North Eastern Regional Power Committee

Sub: 78वीं संरक्षण समन्वय उप-समिति (पीसीसी) बैठक का कार्यवृत्त/ Minutes of 78th Protection Coordination Sub-Committee (PCC) Meeting

78th Protection Coordination Sub-Committee Meeting

Date: 21/04/2025 (Monday)

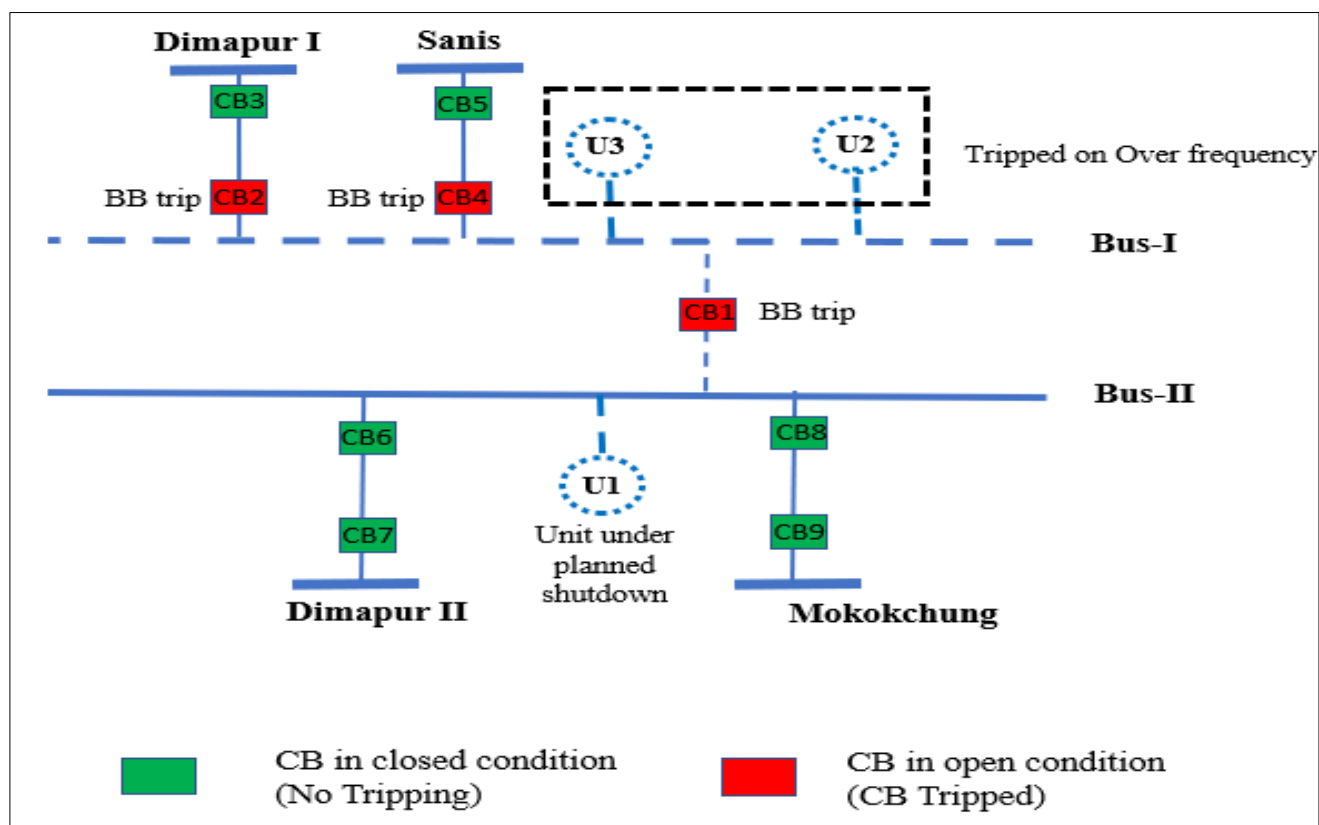
As per DR analysis of 132 kV Doyang-Dimapur I line, R-B ($I_r=1.04\text{kA}$, $I_b=0.9\text{kA}$) fault initiated at 19:59:32.761 Hrs. Fault was cleared within 52 msec from Doyang end on operation of Bus bar Trip. Also, Z5(rev) started at 19:59:32.786 Hrs.

- DR/EL submitted for Doyang Unit-2 and Doyang Unit-3 does not open due to which proper analysis could not be done. NEEPCO is requested to submit correct DR/EL files.

Forum requested NEEPCO to provide all the DR to NERLDC and referred the matter to PSAG for further analysis.
